Access Compliance Report

Public Rights-of-Way

(Curb Ramps)

Intersection ID: 10014956	Main Street: MOODY_RD	Cross Street: N/A	Location: NE
ADA ID: 4AABE6B257E3	Ramp Type: Perp	Initial Pass/Fail: Fail	Overall Compliance: No
Codes/Mitigation Info/Possible Solution		Field Measurements/Component Compliance	
Severity Score: 13.75

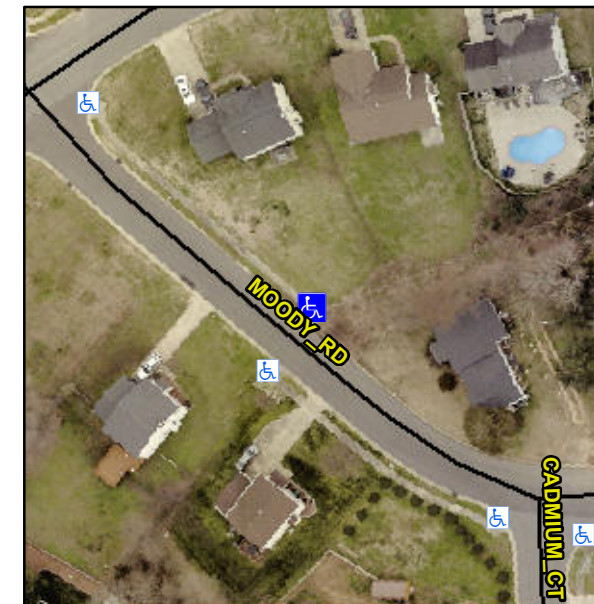
Not Found, R304.2.2, R304.5.3

Compliance	Description	Data	Compliance	Description	Data
N/A	Ramp Length (in)	45.0	No	Ramp Slope (%)	9.6
Yes	Ramp Width (in)	50.0	No	Ramp XSlope (%)	4.8
N/A	Flare Type LT	N/A	N/A	Flare Type RT	N/A
N/A	Flare Slope LT (%)	N/A	N/A	Flare Slope RT (%)	N/A
N/A	Flare Traversable LT?	N/A	N/A	Flare Traversable RT?	N/A
N/A	Landing Length (in)	N/A	N/A	DWS Provided?	N/A
N/A	Landing Width (in)	N/A	N/A	DWS Contrast?	N/A
N/A	Landing Slope (%)	N/A	N/A	DWS Length (in)	N/A
N/A	Landing X Slope (%)	N/A	N/A	DWS Full Width?	N/A
N/A	Landing Curb? (Y/N)	N/A	N/A	DWS Offset (in)	N/A
N/A	Shared Landing?	N/A			
N/A	Gutter Ponding?	N/A	N/A	Gutter Slope (%)	N/A
N/A	Gutter Lip Ht (in)	N/A	N/A	Gutter X Slope (%)	N/A
N/A	Painted X Walk1?	No	N/A	Painted X Walk2?	N/A
	X Walk 1 Direction	To SW		X Walk 2 Direction	N/A
N/A	X Walk 1 Width (in)	N/A	N/A	X Walk 2 Width (in)	N/A
	X Walk 1 Slope (%)	1.6		X Walk 2 Slope (%)	N/A
	X Walk 1 X Slope (%)	3.9		X Walk 2 X Slope (%)	N/A

Remove & Replace Entire Ramp.
